AUTOMATIC TRANSMISSION SERVICE GROUP

SEMINARS '88

TECHNICAL INFORMATION PACKAGE

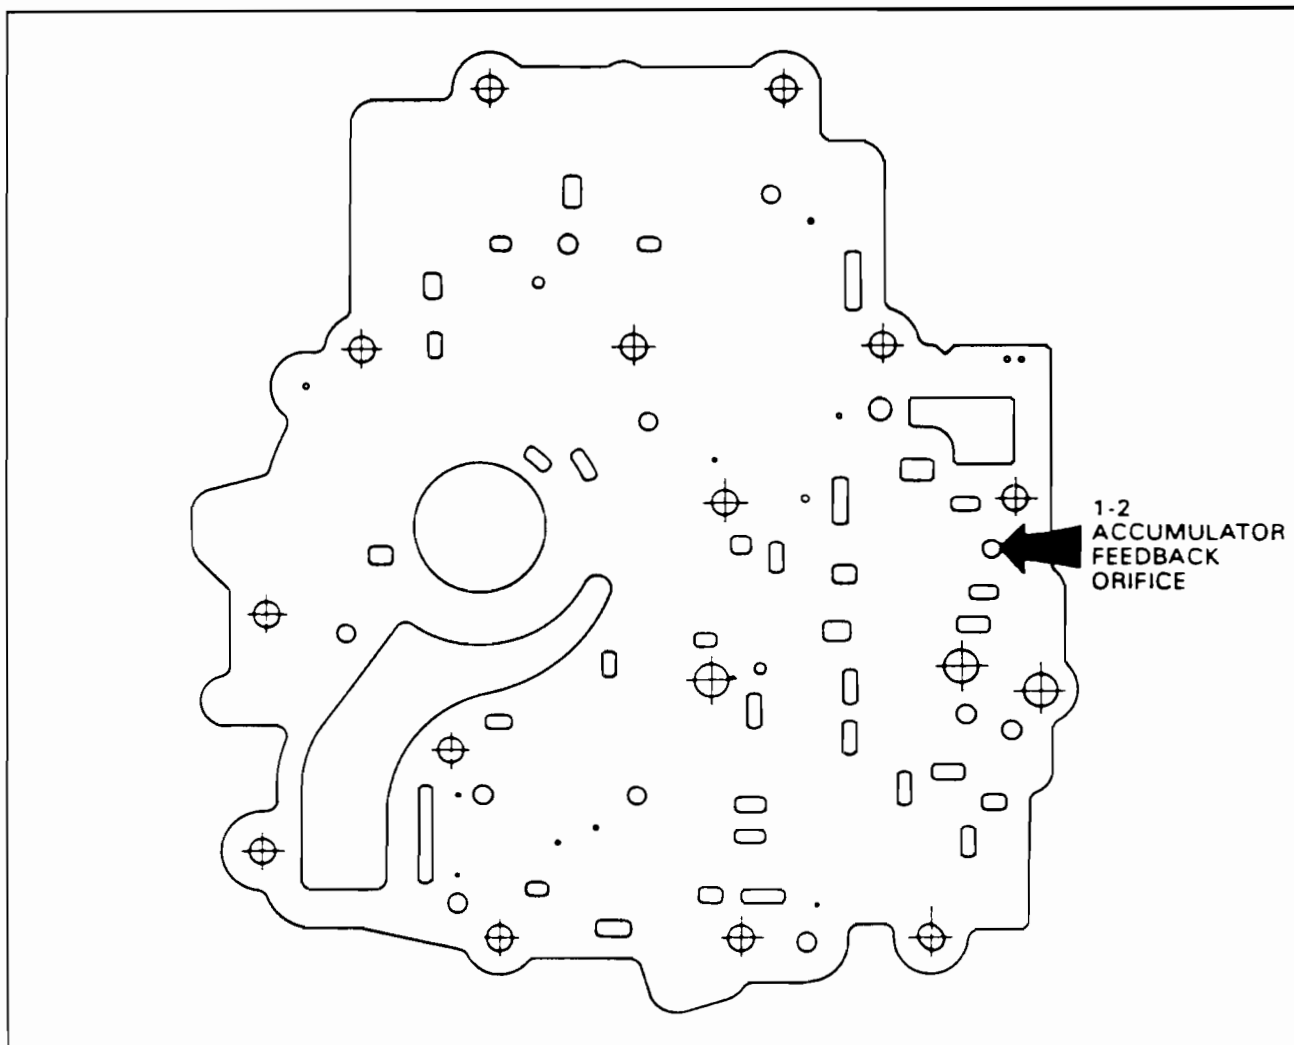
COMPLAINT: Harsh 1-2 shift encountered on 1985-86 Thm 125C transmissions

CAUSE: Too small an orifice in separator plate (.040) 1-2 ACCUMULATOR FEED BACK ORIFICE.

CORRECTION: Drill orifice to (.125) or replace with part number 8660581

Figure 1

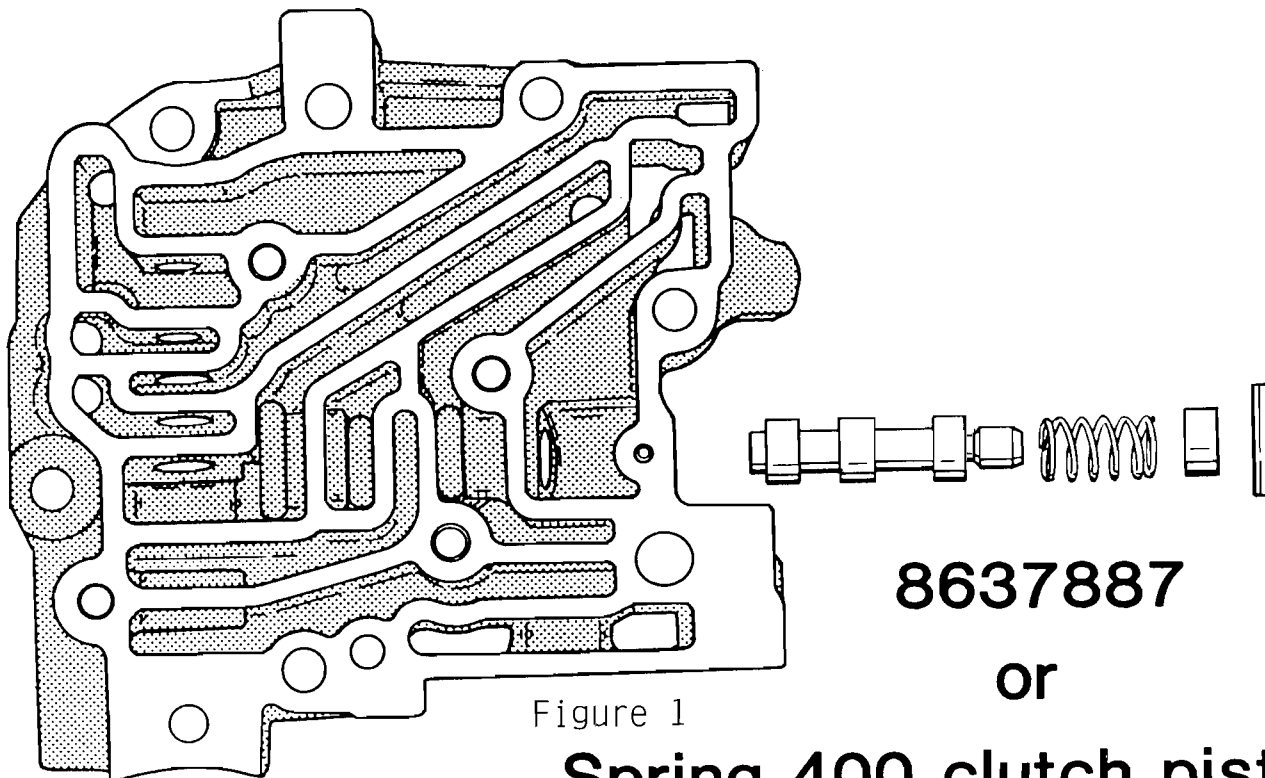
COMPLAINT: CONVERTER CLUTCH SHUDDER

CAUSE: One cause can be low converter regulator charge pressure. Figure 1. Another cause can be slow drain of converter oil in front of clutch piston.

CORRECTION: Install stronger regulator valve spring 8637887 or use a spring from a Thm 400 forward or direct clutch retainer
Figure 2 Drill converter exhaust hole in separator plate to .080

Figure 1 - THM 200C Transmission Nameplate

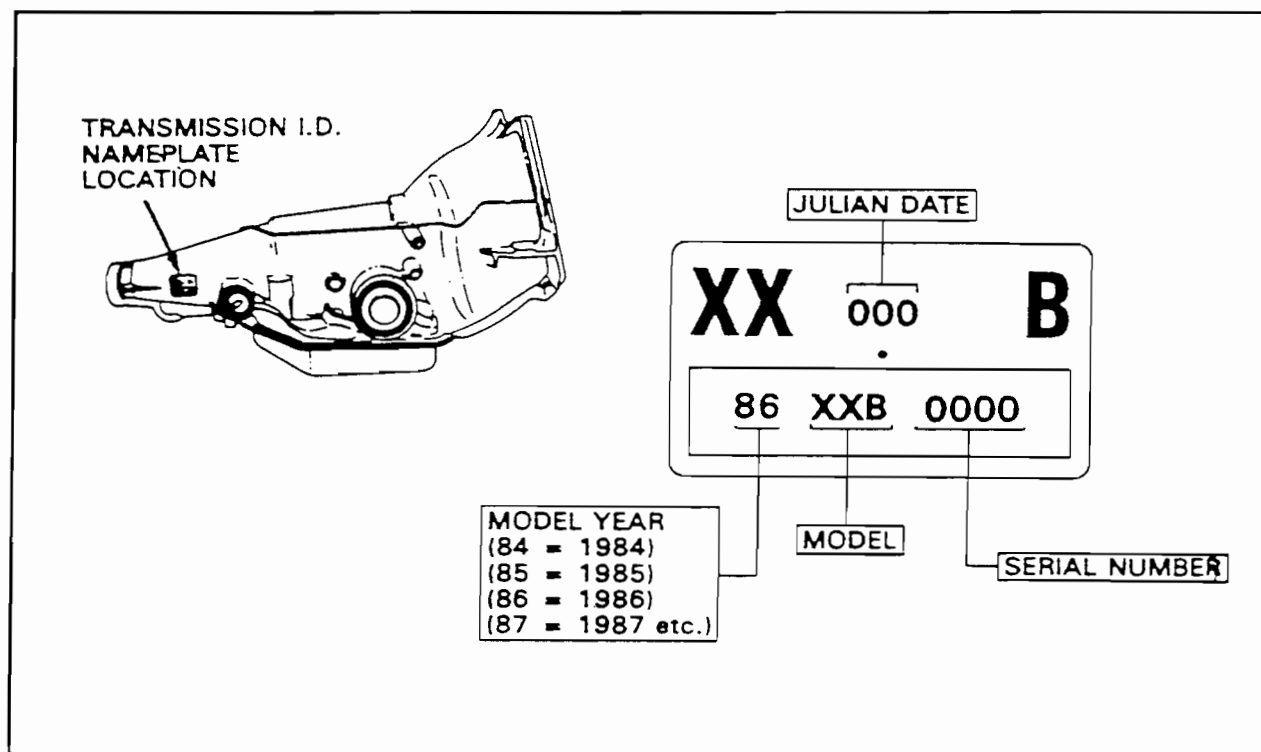
1987 THM 200C transmissions are being built with a new design "feed/bleed" system for the forward clutch. This system gives more cushioning during forward clutch apply and can be used on certain past models to reduce a harsh park/neutral to drive engagement feel.

DATE OF PRODUCTION CHANGE: (Figures 1 and 2)

August 4, 1986 (Julian Date 216). These changes were introduced for all THM 200C models:

Figure 1

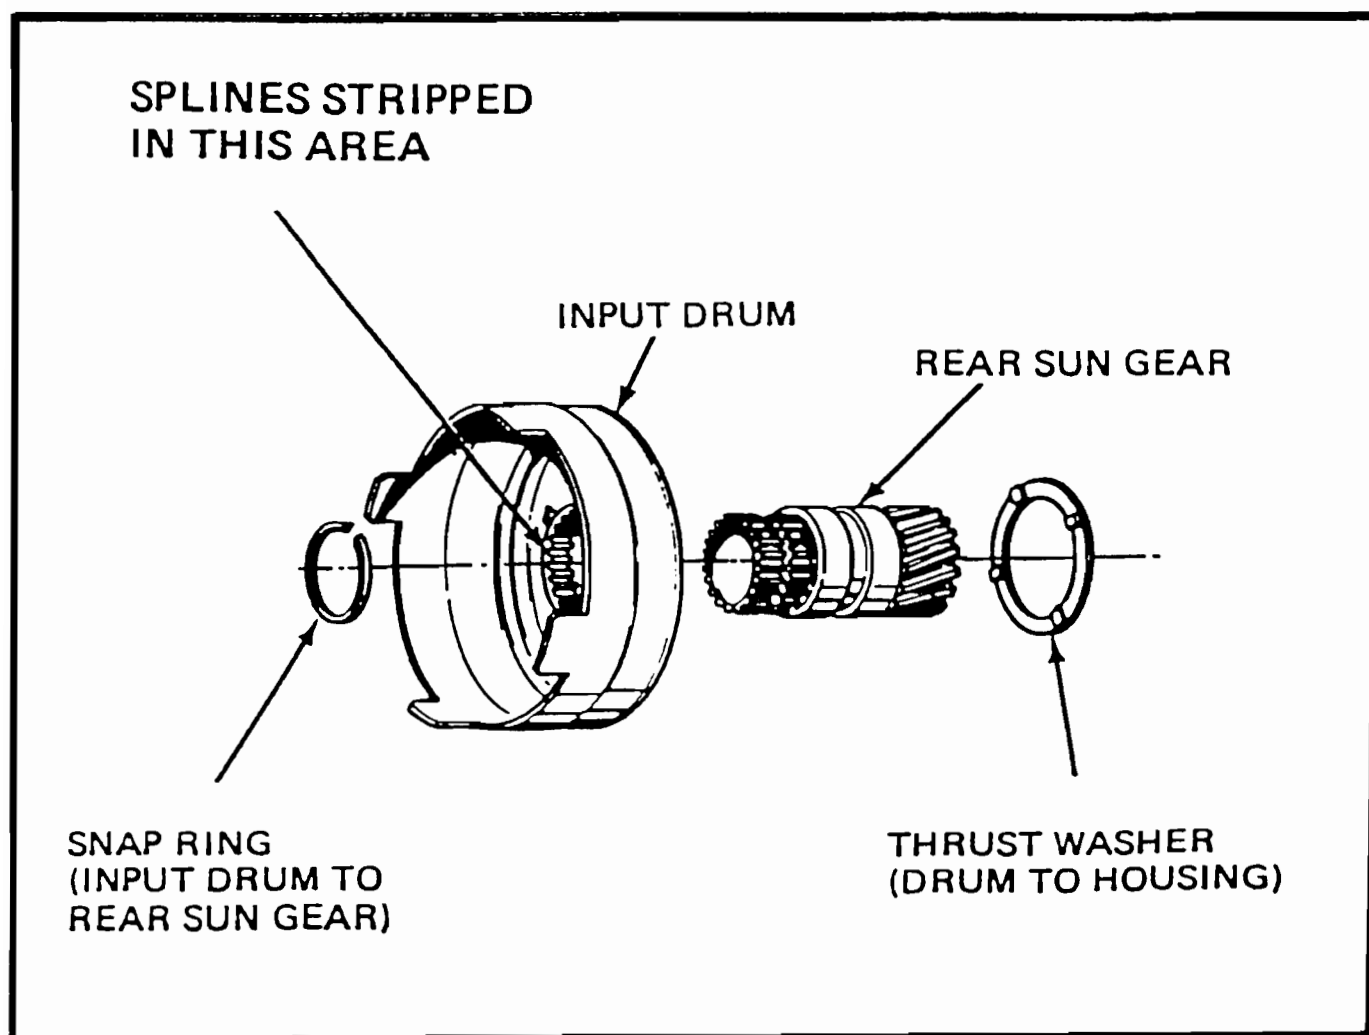
COMPLAINT: No Reverse no upshifts, low gear only.

CAUSE: Stripped splines on the sun gear shell as shown in Figure 1.

CORRECTION: Replace the sun gear shell. If the vehicle is used in heavy duty operation (police-taxi) a new hardened shell is available. It is a flat black in color.

Figure 2

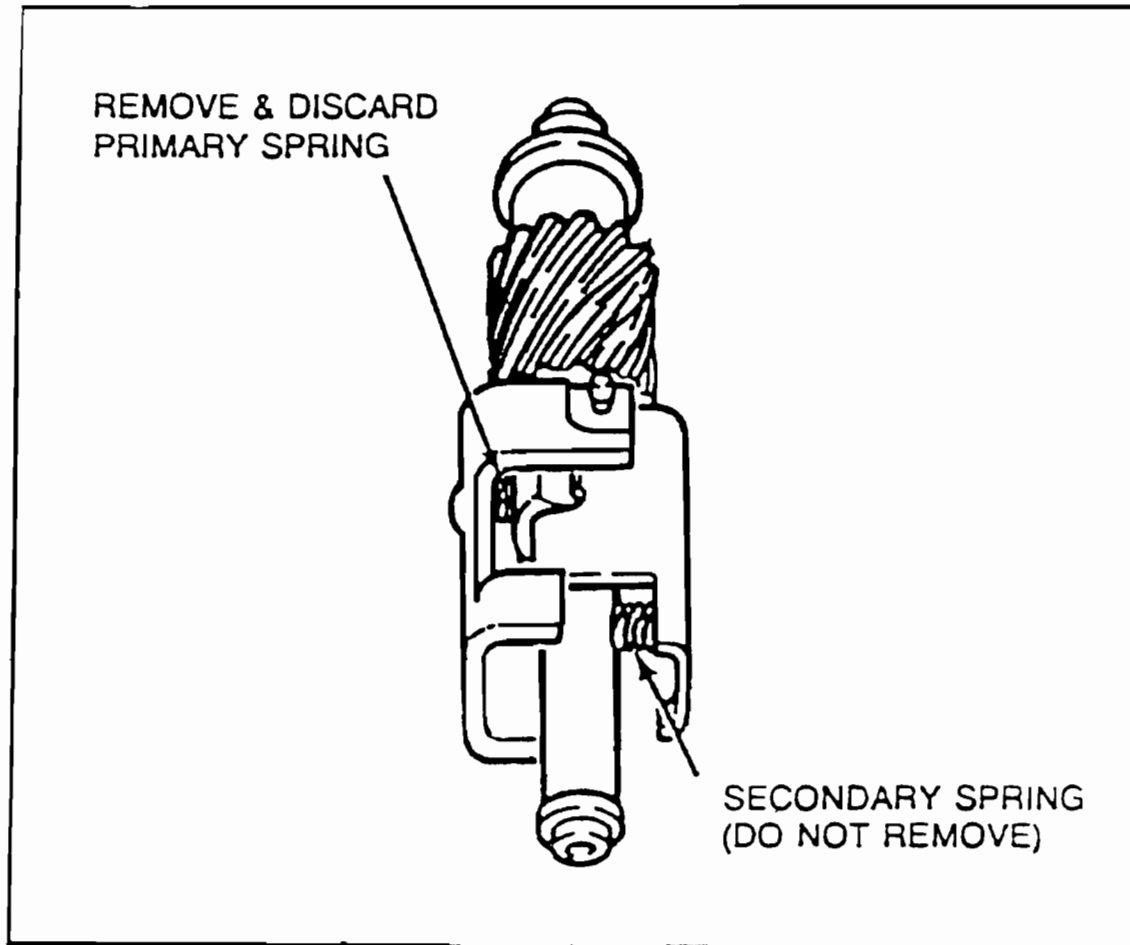
On a 1984 or 1985 200C Built prior to september 25 1985 (see juilian date on ID tag) Of a down shift clunk on the 2-1 downshift. 1984-1986 Delta 88 Cutlass Supreme

Check engine idle speed and set to specs, Check differential for excessive backlash. On 1984 or 1985 "BH" Models remove the primary spring from the governor figure 2.

Figure 5

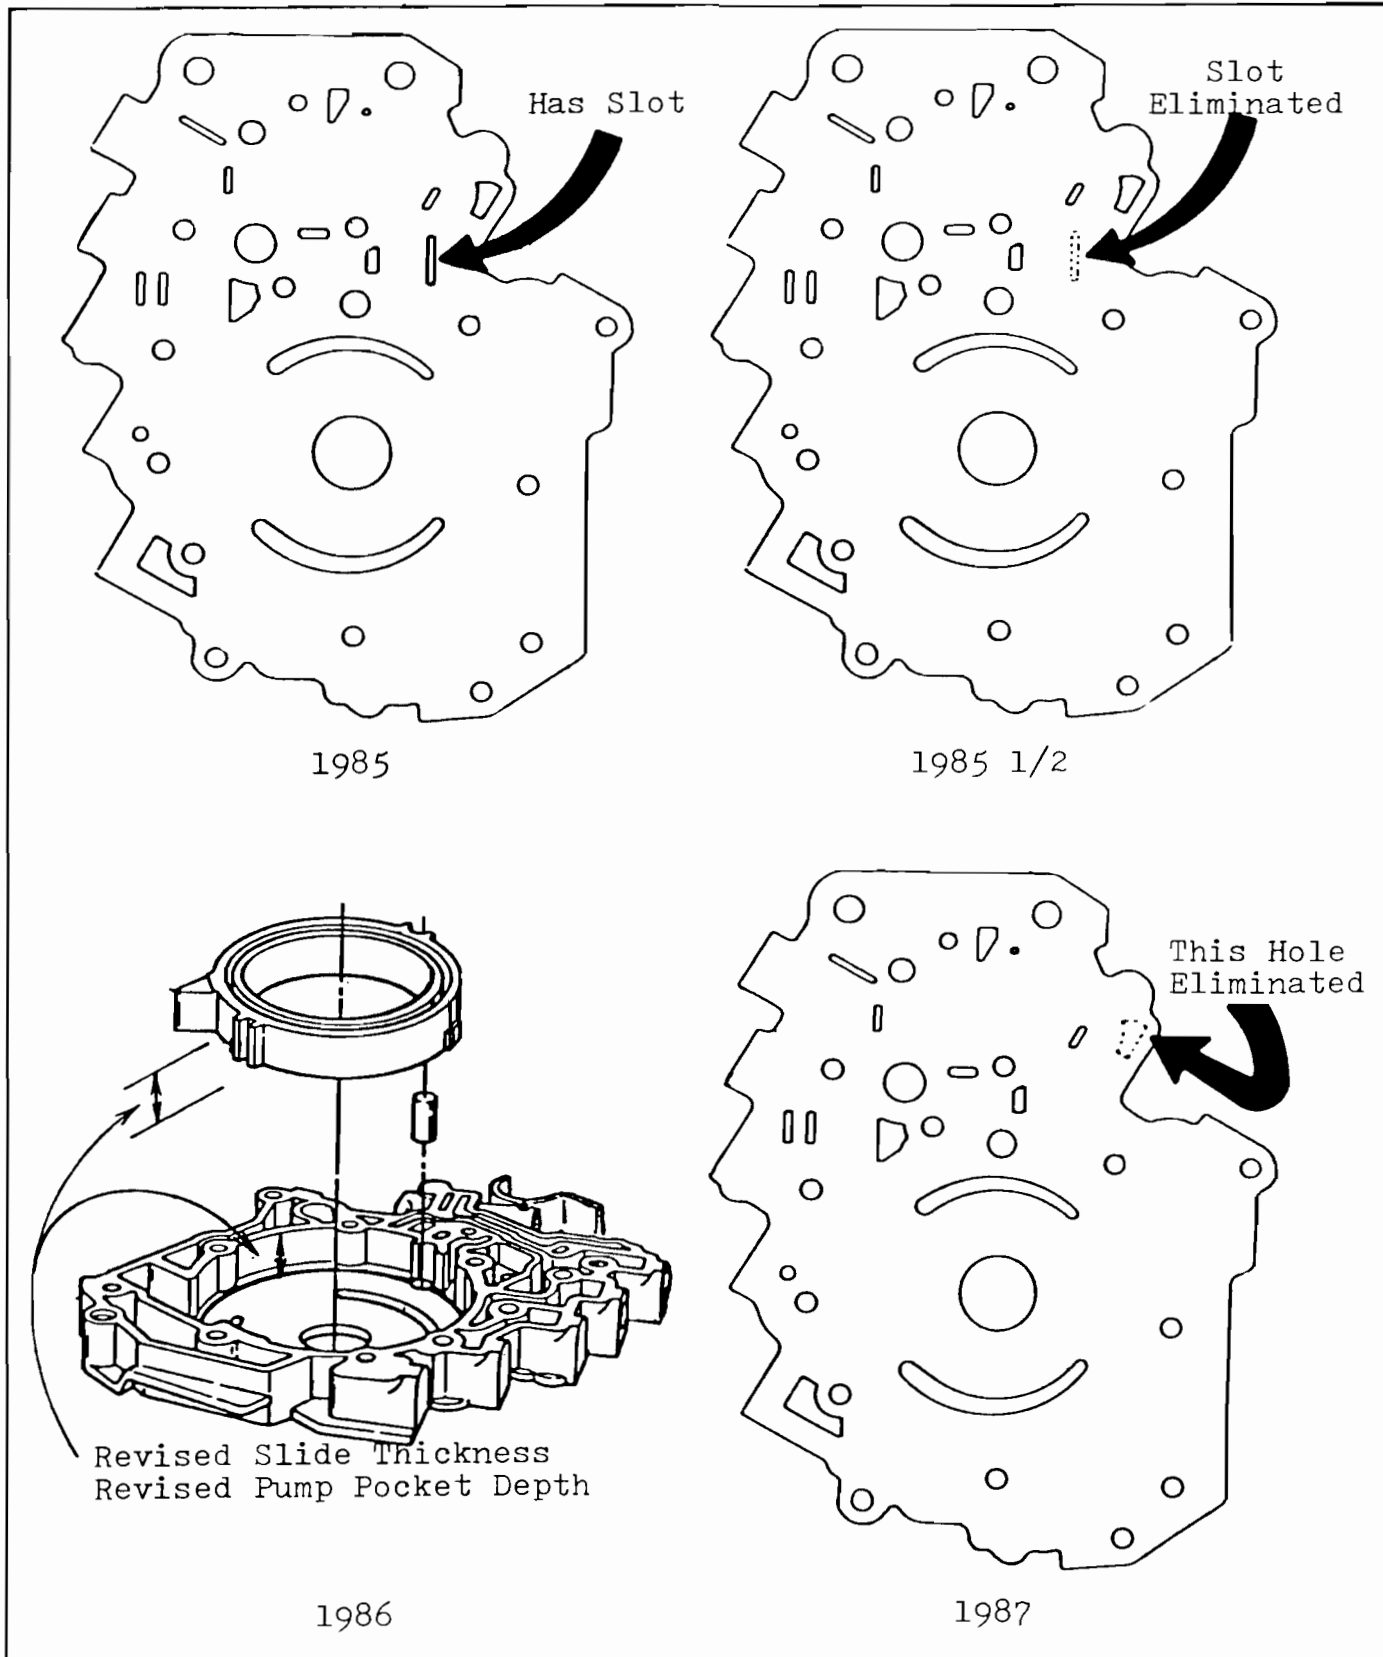
1985	Identification:	Has slot in pump body (See Figure 5).
	Interchangeability:	The 1985 pump body will not work on 1985 1/2 up valve body unless spacer plate is used to eliminate slot. If used without the spacer plate result will be tie-up when transaxle shifts to 4th gear.
1985 1/2	Identification:	Slot in pump body was eliminated (See Figure 5).
	Reason:	Addition of 3-2 TV bias valve in valve body and complete revision of hydraulic circuit for improved 3-2 downshift.
	Interchangeability:	Will interchange on 85 1/2 and 1986 models only.
1986	Identification:	No way to identify from 1985 1/2. Pump pocket depth was made shallower by .0001" which created 5 new slide sizes unique to the 1986 pump. See chart on page 6.
	Reason:	Improved pump capacity.
	Interchangeability:	Will interchange with 85 1/2 only, as long as proper slide selection is made to correspond with depth of pump pocket.
1987	Identification:	Hole eliminated in pump body (See Fig. 5).

Reason:	Improved 3-2 downshift. Modulator oil was fed thru the hole in pump body to stroke the 3-2 coastdown valve. Improved 3-2 downshift could be obtained by using servo release oil to stroke the valve, so hole was eliminated and the 3-2 maneuver pipe was added to carry servo release oil to the 3-2 coastdown valve in pump body (See Figure 6). This also made a change in the pump cover necessary with an additional hole and seal to accept the 3-2 maneuver pipe.
	Interchangeability:	Will retro fit back to 85 1/2, and is recommended. The 3-2 maneuver pipe must be used with it. Not interchangeable unless 3-2 maneuver pipe is used.

Figure 1

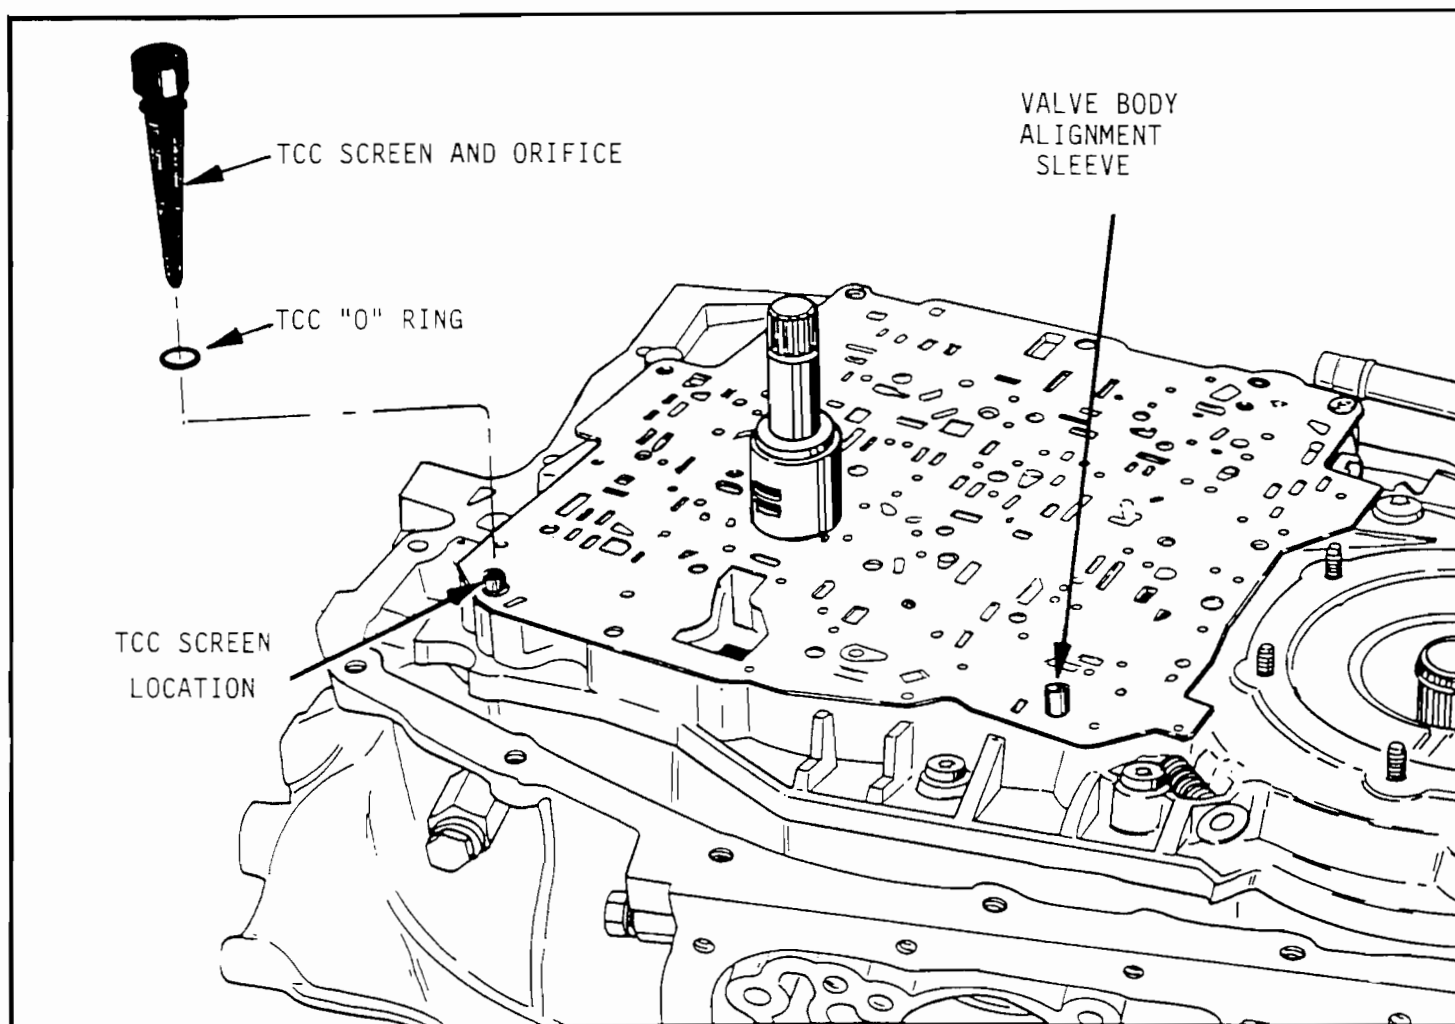
COMPLAINT: Premature Lock-up, - Sometimes described as No Lock-up.

CAUSE: The cause may be a missing TCC screen and orifice (See Figure 1). If the TCC screen and orifice are left out of the 440-T4, the converter clutch will apply on the 1-2 shift, because of the solenoids inability to exhaust TCC signal oil there by stroking the lock-up valve. The TCC screen and orifice must be in place, as well as the "O" ring (See Figure 1).

CORRECTION: Install the TCC screen and "O" ring into spacer plate in location shown in Figure 1. First install "O" ring on TCC screen and then "Snap" into place in spacer plate. OEM Part No's as follows;
TCC Screen-----8658060 "O" Ring, TCC Screen-----8658109
